Access Compliance Report Public Rights-of-Way (Curb Ramps)

Main Street: OAK_KNOLL_DR Cross Street: MONTECITO_RD Location: NW

ADA ID: RPRK211220111723 Ramp Type: Type 1 - Perpendicular Diagonal Initial Pass/Fail: Pass Overall Compliance: No Severity Score: 0

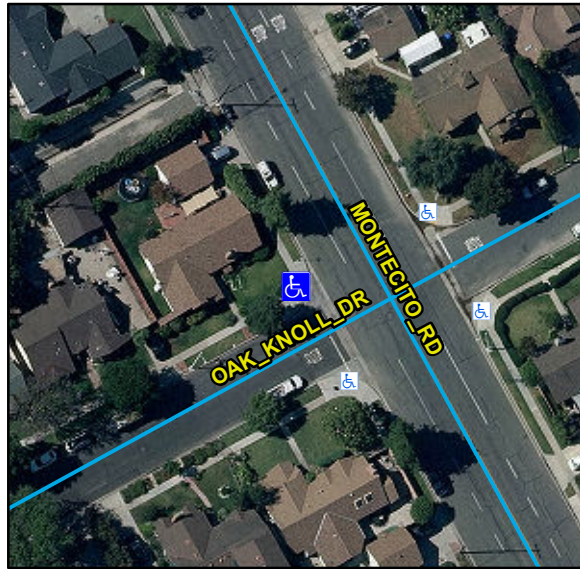
R304.2.2, R304.2.1, STD 1115

Remove & Replace Curb Ramp With Two New Directional Ramps or Equivalent.
